Before the
United States Nuclear Regulatory Commission
Docket Nos. STN 50-498, STN 50-499
Houston Lighting & Power Company, et. al.
South Texas Project Units 1 & 2
Amendment 5

Houston Lighting & Power Company, an applicant in the above captioned proceeding, for itself and for the City of San Antonio, Central Power & Light Company and the City of Austin, hereby files Amendment 5 to the Environmental Report - Operating License Stage.

APPENDIX E
SOUTH TEXAS PROJECT
UNITS 1 AND 2

RESPONSES TO NRC
APRIL 28, 1982
REQUEST FOR ADDITIONAL INFORMATION

FIGURE 2.2-2

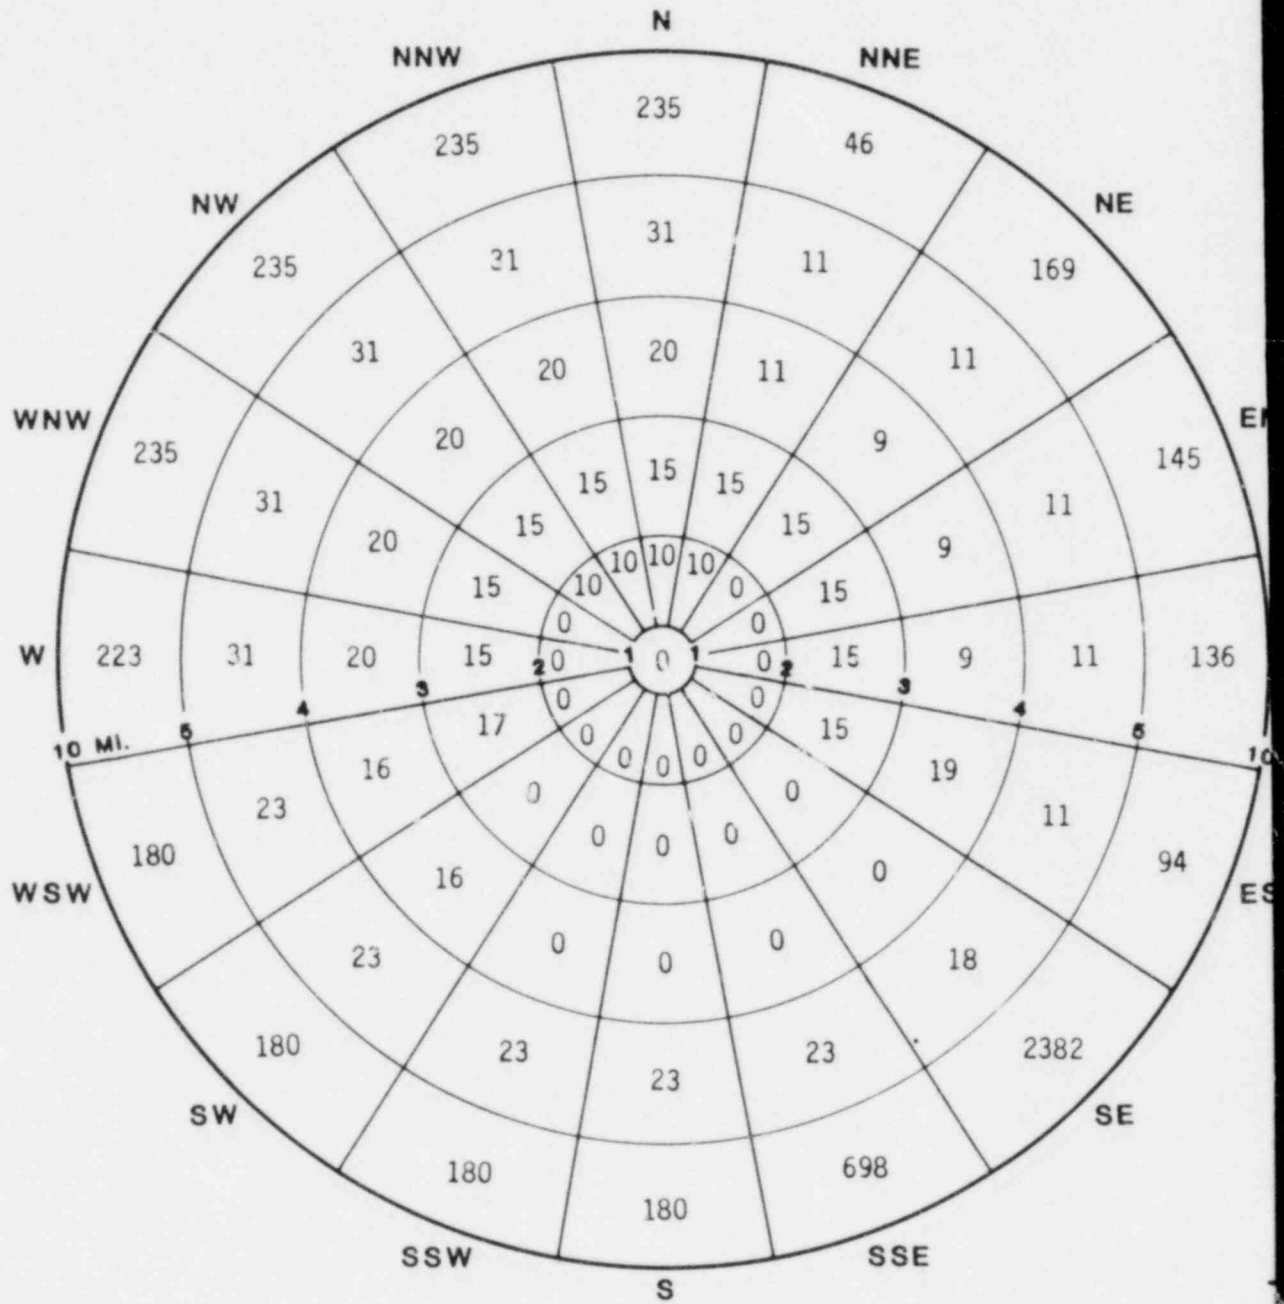
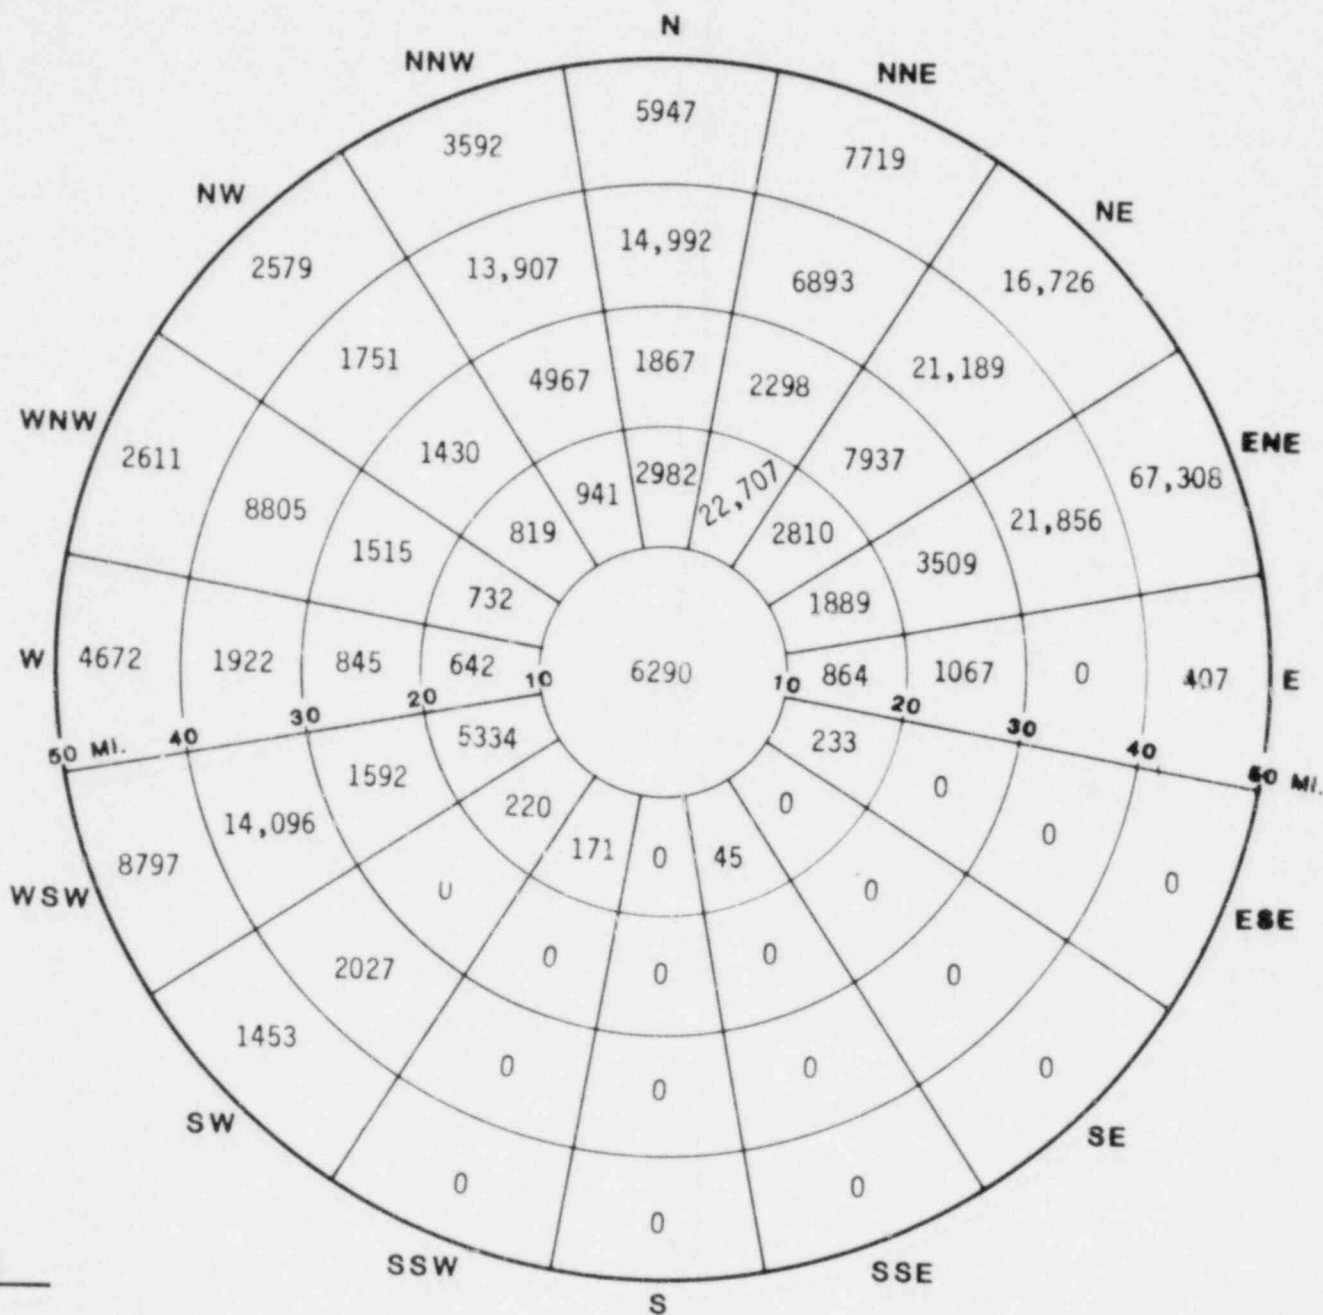
The current population documentation is outdated, and in some instances inconsistent. Please provide an updated Section 2.1.3 which incorporates the 1980 census population data including population projections to the year 2030. Please revise the figures and tables so that they are consistent with the text.

Requested information is provided in revised Section 2.1.3.
